CONTRACT CHANGE ORDER NO. 128S1
SHEET 2 OF 3

SAN FRANCISCO OAKLAND BAY BRIDGE EAST SPAN SEISMIC SAFETY PROJECT
SELF-ANCHORED SUSPENSION BRIDGE (SUPERSTRUCTURE & TOWER)

TOWER ACCESS DETAILS NO. 16B

TOWER ACCESS DETAILS NO. 16D

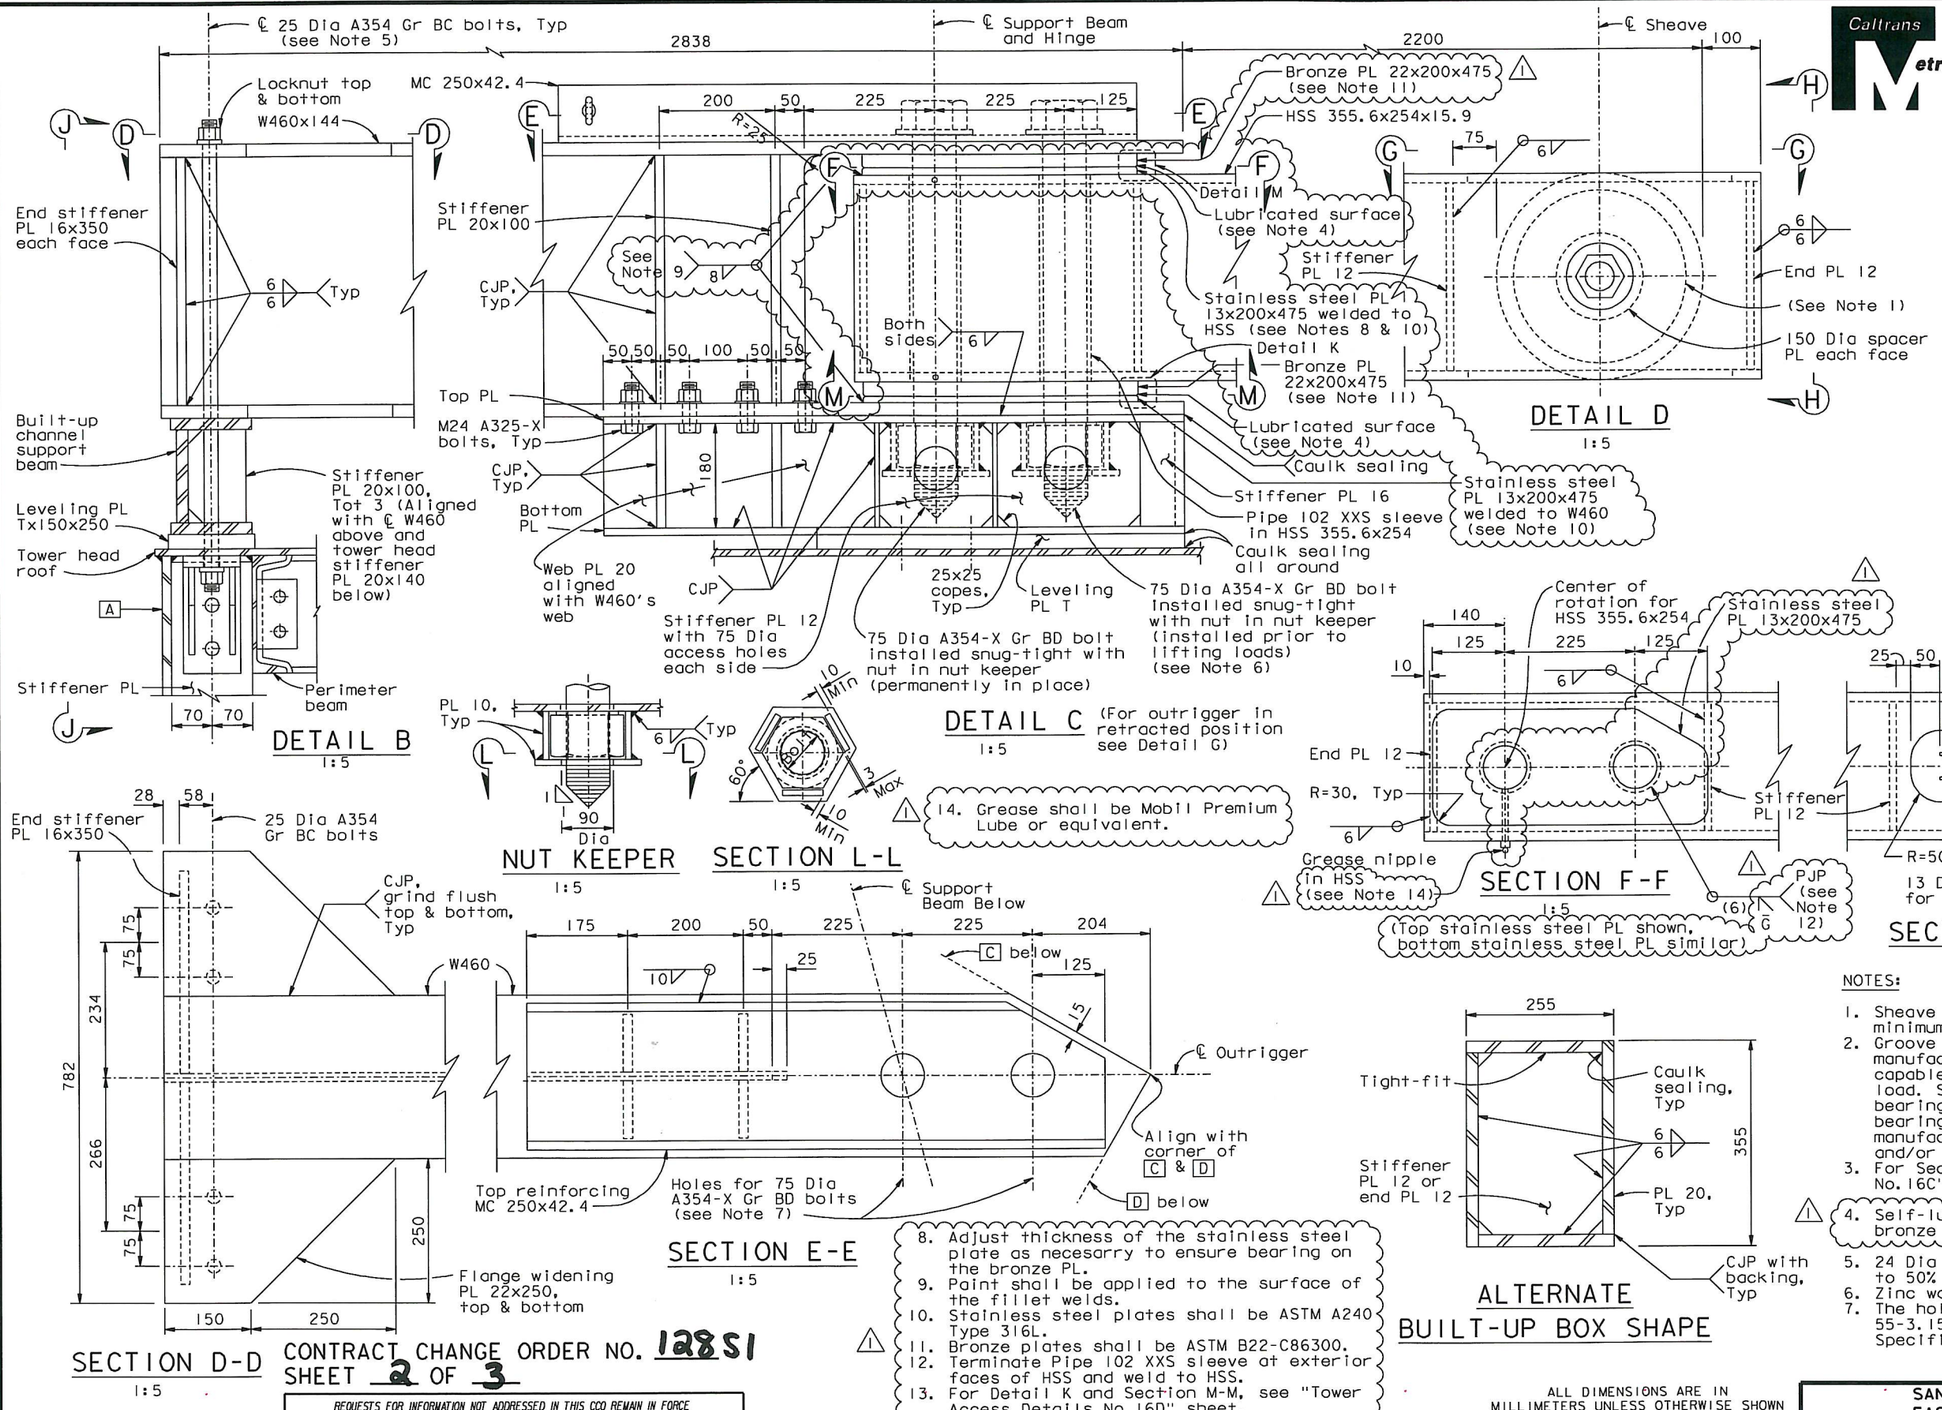
MARK	DATE	DESCRIPTIONS	BY	CH'D	CCO#
1	06/14/11	TOWER BOOM BEARINGS	CC	MN	128S1
0	10/30/09	TOWER MAINTENANCE ENHANCEMENTS	JC	MN	128

8. Adjust thickness of the stainless steel plate as necesarry to ensure bearing on the bronze PL.
9. Paint shall be applied to the surface of the fillet welds.
10. Stainless steel plates shall be ASTM A240 Type 316L.
11. Bronze plates shall be ASTM B22-C86300.
12. Terminate Pipe 102 XXS sleeve at exterior faces of HSS and weld to HSS.
13. For Detail K and Section M-M, see "Tower Access Details No.16D" sheet.

1. Sheave shall be min 350 mm Dia with a minimum unfactored service load of 75 kN.
2. Groove width shall be determined by manufacturer to accommodate the wire line capable of lifting the unfactored service load. Sheave shall be supplied with a roller bearing, a tapered roller bearing or a roller bearing with thrust washer. The sheave manufacturers shall provide the fasteners and/or pin for the sheave.
3. For Section J-J, see "Tower Access Details No.16C" sheet.
4. Self-lubricated lubricant shall be applied to bronze plate.
5. 24 Dia A354 Gr BC bolts shall be pretensioned to 50% of their ultimate tensile strength.
6. Zinc wax or grease threaded components.
7. The hole size shall confirm with Section 55-3.15 "Pin Connections" of the Standard Specifications.

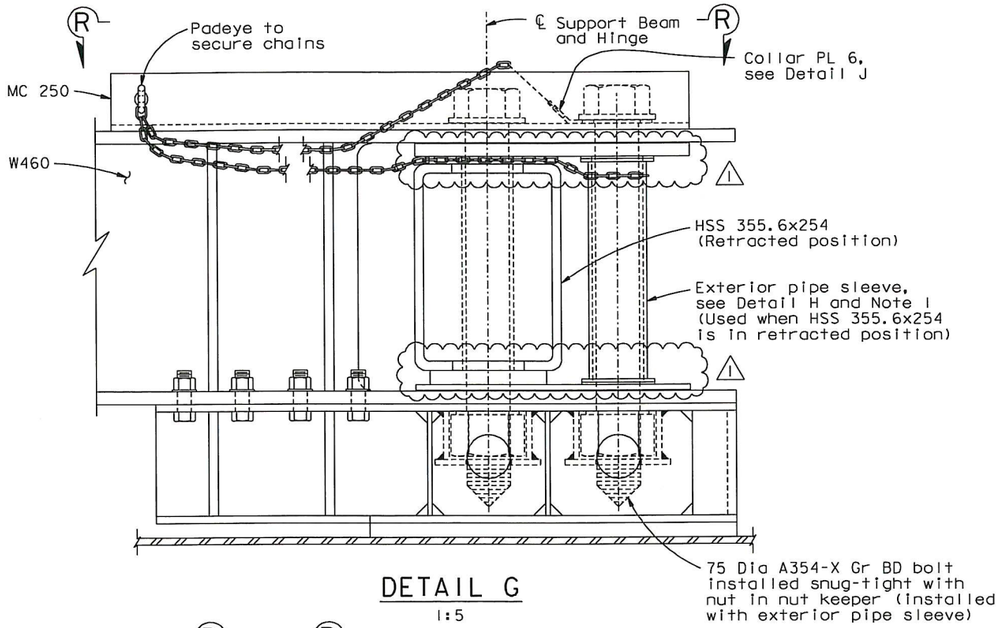
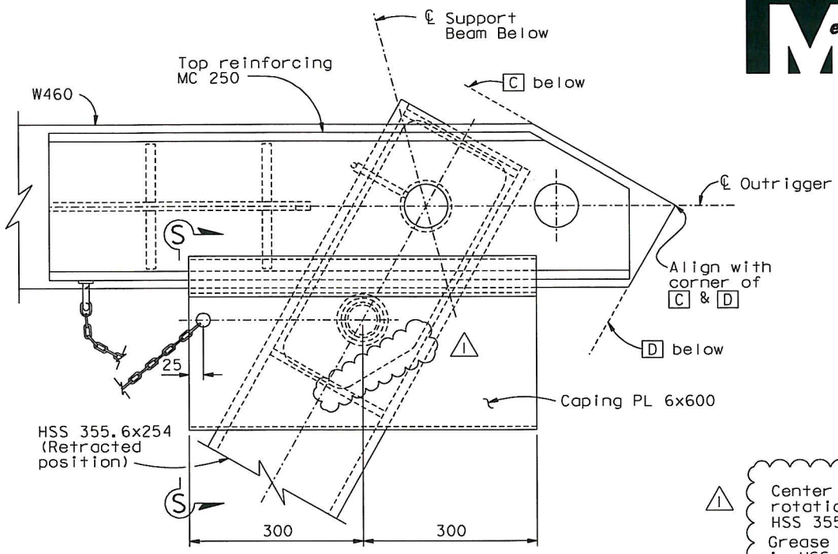
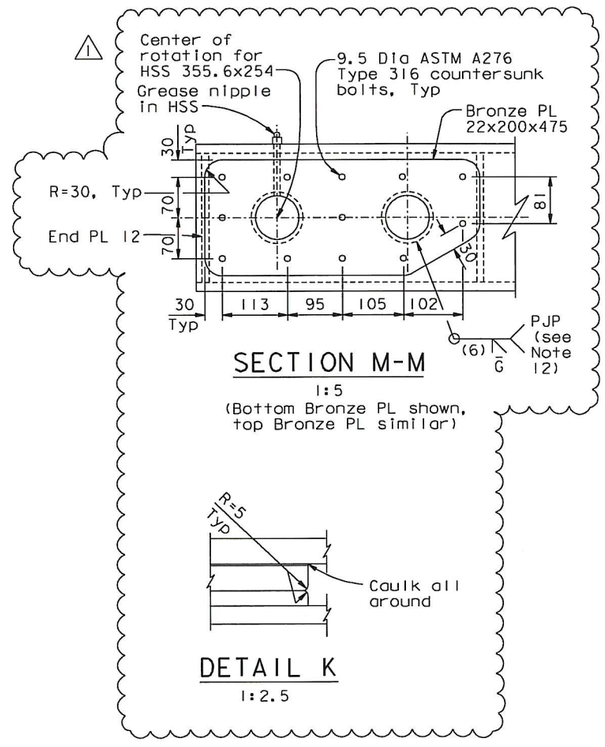
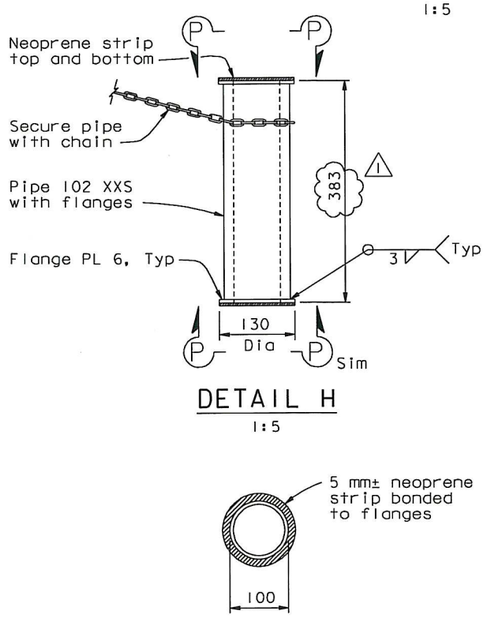
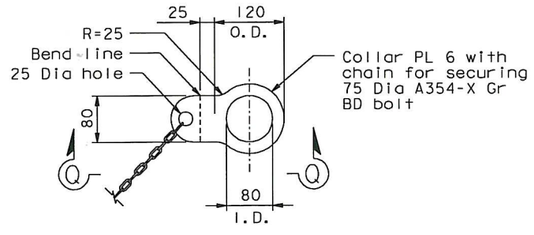
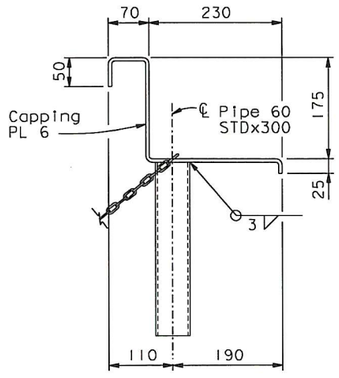
MARK	DATE	DESCRIPTIONS	BY	CH'D	CCO#
1	06/14/11	TOWER BOOM BEARINGS	CC	MN	128S1
0	10/30/09	TOWER MAINTENANCE ENHANCEMENTS	JC	MN	128

1. The exterior pipe sleeve shall be placed to bear on the flanges of W460. Adjust thickness of neoprene strips as needed.
